Access Compliance Report

Public Rights-of-Way

| Intersection ID: 43762 | Main Street: HELENS_LN | Cross Street: ZIEGLER_LN | Location: NE |
| ADA ID: 301A8525FC0D | Ramp Type: PerpDiag | Initial Pass/Fail: Fail | Overall Compliance: No |

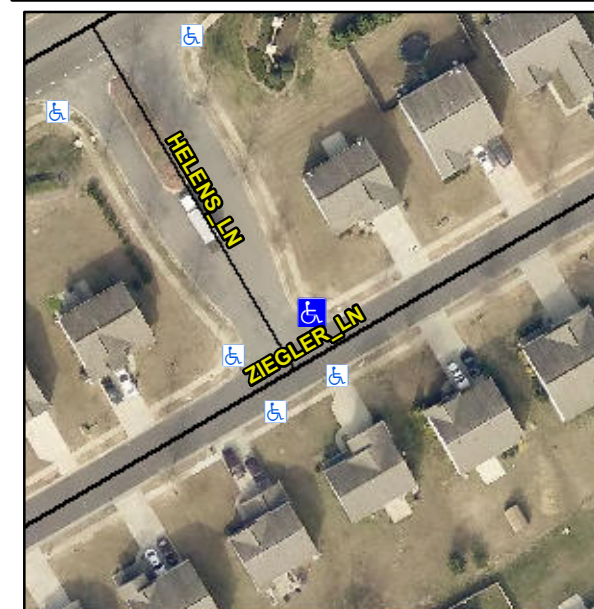
R304.5.1, R304.2.2

| Compliance | Description | Data | Compliance | Description | Data |
|------------|-----------------------|------|------------|-----------------------------|------|
| N/A | Ramp Length (in) | 46.0 | No | Ramp Slope (%) | 10.8 |
| No | Ramp Width (in) | 38.0 | Yes | Ramp XSlope (%) | 1.6 |

Remove & Replace Curb Ramp With Two New Directional Ramps or Equivalent.
